Bulletin No.: 20760B
Date: March 2016

PRODUCT SAFETY RECALL

SUBJECT: Brake Pedal Pivot Nut/Bolt Loose

MODELS: 2015 - 2016 Chevrolet Silverado Crew Cab LD with Special Services (RPO 5W4)
2015 - 2016 Chevrolet Silverado HD
2015 - 2016 Chevrolet Tahoe PPV (RPO 9C1)
2015 - 2016 Chevrolet Tahoe with Special Services (RPO 5W4)
2015 - 2016 GMC Sierra HD

4404307

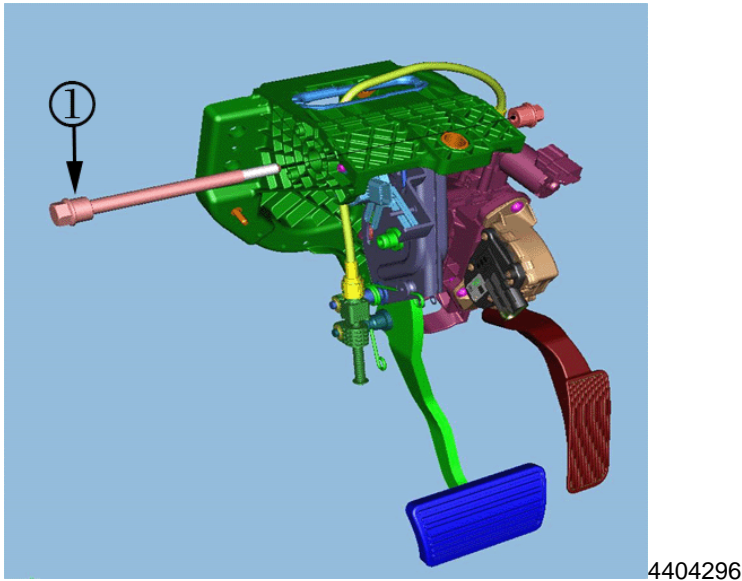
- Using an inspection mirror, determine if the brake pedal pivot nut is on the outboard side of the vehicle.

- If the brake pedal pivot nut (1) is on the outboard side of the vehicle, proceed to step 2.

- If the brake pedal pivot bolt (1) is on the outboard side of the vehicle (nut on the inboard side), no further action is required.
2. Determine if the vehicle is equipped with a manual or automatic transmission.
 - If the vehicle is equipped with a manual transmission remove the clutch pedal. Refer to *Clutch Pedal Replacement* in SI. After the clutch pedal has been removed, proceed to step 5.
 - If the vehicle is equipped with an automatic transmission, proceed to step 3.
 3. Remove the Instrument Panel Knee Bolster. Refer to *Instrument Panel Knee Bolster Replacement* in SI.
 4. Remove the Floor Front Air Outlet Duct - Left Side. Refer to *Floor Front Air Outlet Duct Replacement - Left Side* in SI.

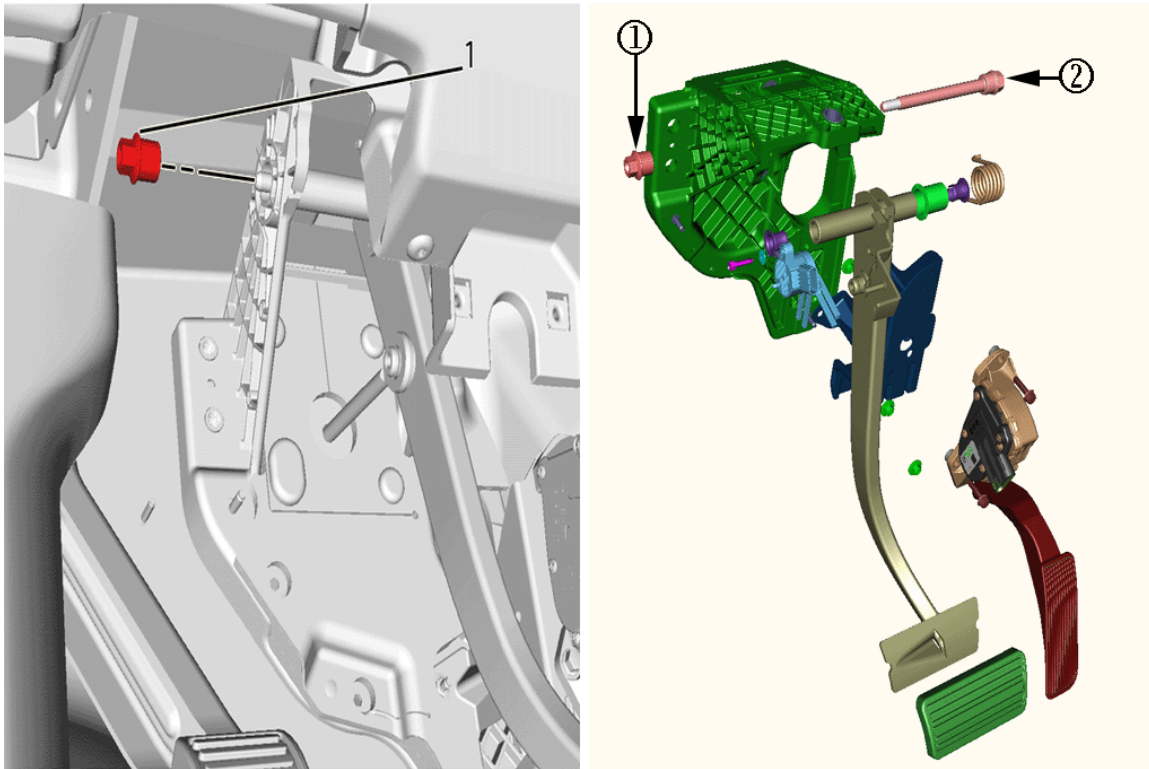
Caution: Apply pressure to the brake pedal pivot bolt while removing the nut to ensure the bolt does not back out of the housing. Part damage could occur if the bolt backs out of the housing.

5. Holding the brake pedal pivot bolt (2) with a box end wrench, remove the brake pedal pivot nut (1).

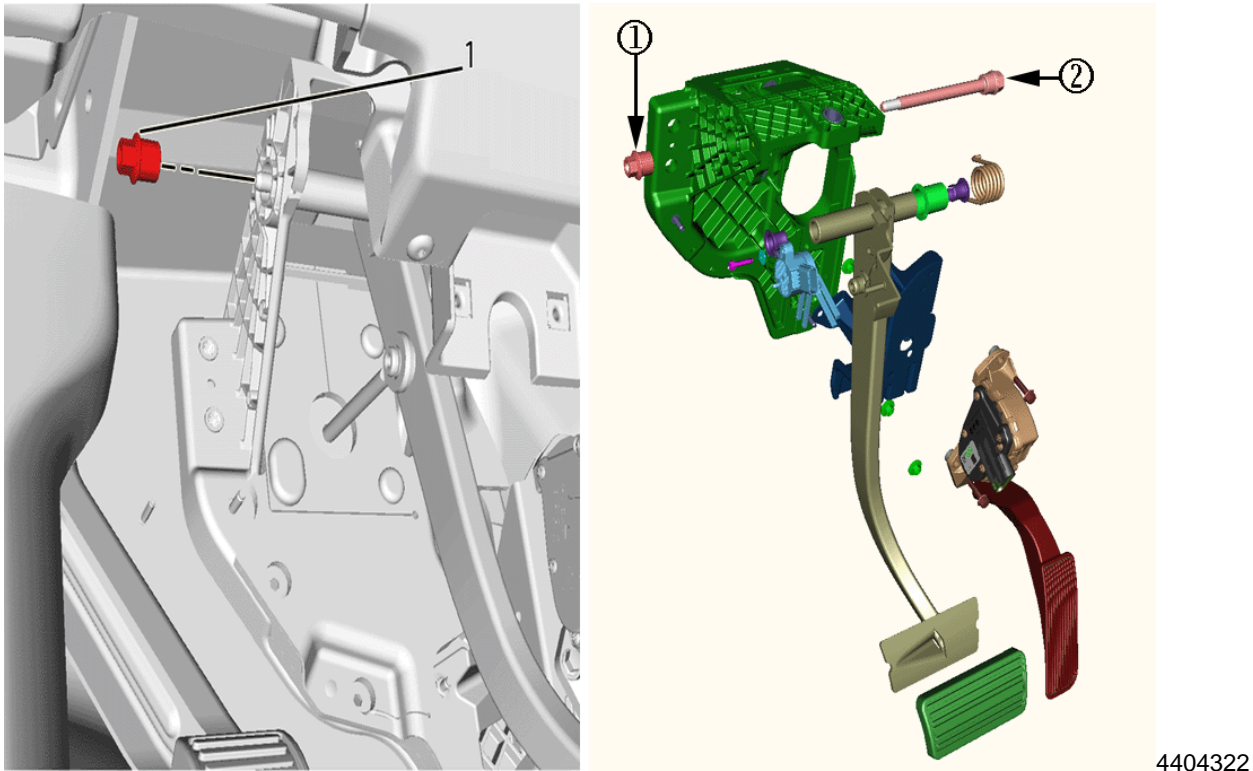
Note: Do NOT get threadlocker on the exterior of the brake pedal pivot nut. The exterior of the brake pedal pivot nut must be kept clean of threadlocker.

6. Holding the nut horizontally, apply two drops of red threadlocker to the threads in the collar portion (1) of the nut.

7. Holding the brake pedal pivot bolt (2) with a box end wrench, install the brake pedal pivot nut (1).
8. Holding the brake pedal pivot bolt with a box end wrench, torque the brake pedal pivot nut to 26 Nm (19 lb ft).
9. On vehicles equipped with a manual transmission, install the clutch pedal. Refer to *Clutch Pedal Replacement* in SI.
10. Install the Floor Front Air Outlet Duct - Left Side. Refer to *Floor Front Air Outlet Duct Replacement - Left Side* in SI.
11. Install the Instrument Panel Knee Bolster. Refer to *Instrument Panel Knee Bolster Replacement* in SI.
